*****ERRATA SHEET*****

THE FOLLOWING CHANGES ARE TO BE MADE TO THE PAGES INDICATED IN THE ASSEMBLY MANUAL. BE SURE TO READ THESE OVER CAREFULLY.

4K MEMORY BOARD ERRATA

DISPLAY/CONTROL BOARD CAPACITOR MODIFICATIONS

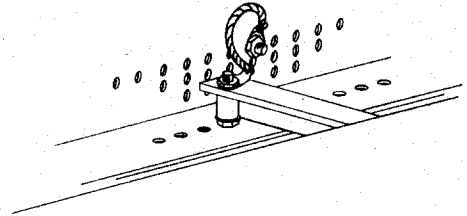
The first connection is to be made between the display/control board and the chassis.

- (✓) Cut a length of the 1/8 inch braid approximately 3 inches and solder a solder lug in place on each end.
- (✓) Referring to the drawing below, attach the braid between the 7805 mounting screw on the back side of the display/control board and the chassis as shown.

NOTE: At any point where a connection is made to the chassis, first rub the area around the connection point with sandpaper or some other abrasive to remove the anodizing.

This connection should be insulated using heat-shrink or some other such tubing.

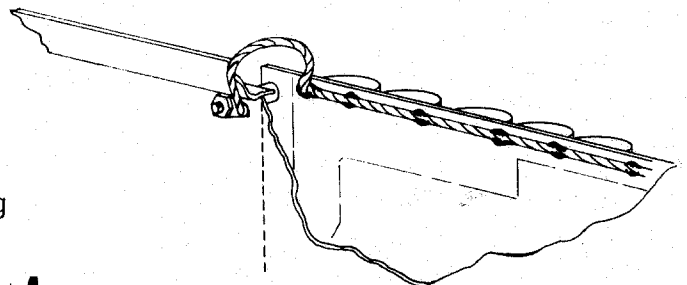
- (✓) Prepare another length of 1/8 inch braid in exactly the same manner as the first piece.
- (✓) Connect this braid between the card rail towards the back of the unit on the side opposite the transformers and the chassis as shown in the drawing below.

- (✓) The 1/4 inch braid is to be soldered directly to the PC land on the bottom (non silk-screened) side of the power supply board. Solder this braid in place along its entire length between the negative side of C1 and the positive side of C14. (see drawing below)
- (✓) Prepare a 4 inch length of 1/8 inch braid by attaching a solder lug to one end.
- (✓) Solder the end opposite the lug on the 4 inch length to the end of the 1/4 inch braid beneath capacitor C1 as shown in the drawing below. The end of the 1/8 inch braid with the solder lug will be attached to the bottom side of the cross member with the same screw which mounts the closest corner of the power supply board.

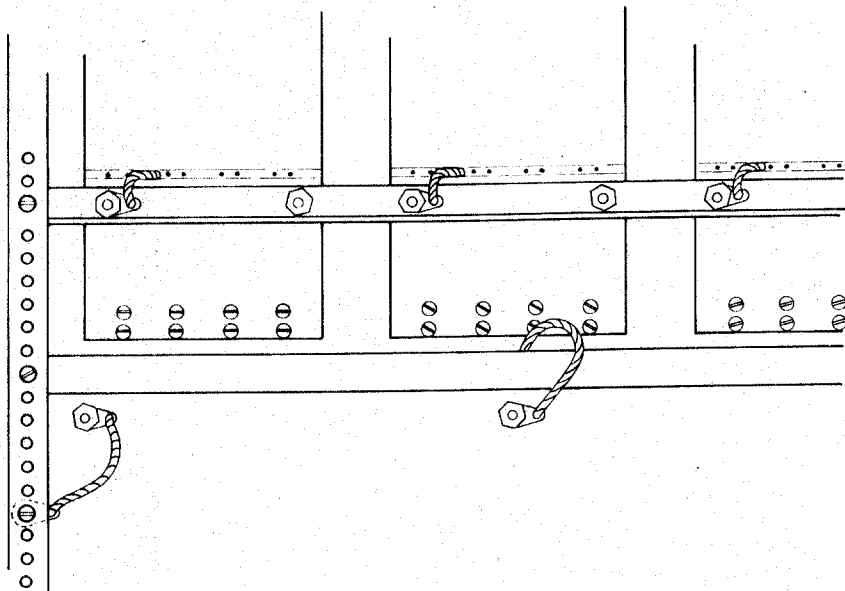
() Prepare another 3 inch length of 1/8 inch braid by attaching solder lugs to each end.

() Connect this length of braid between the cross member on the side opposite the transformers and the chassis as shown in the drawing below.

NOTE: The drawing below also shows the 4 inch length of braid from the power supply board properly attached to the cross member as previously instructed.

() Prepare a 3 inch length of 1/8 inch braid for each of the expander boards in your kit by attaching a solder lug to one end.

() Connect these wires between the card rail and the expander boards as shown in the drawing below. The end of the braid opposite the lug should be soldered directly to the land on the expander board which runs along the edge connecting pins 50 and 100 of each connector. Be very careful not to create any solder bridges when making this connection.
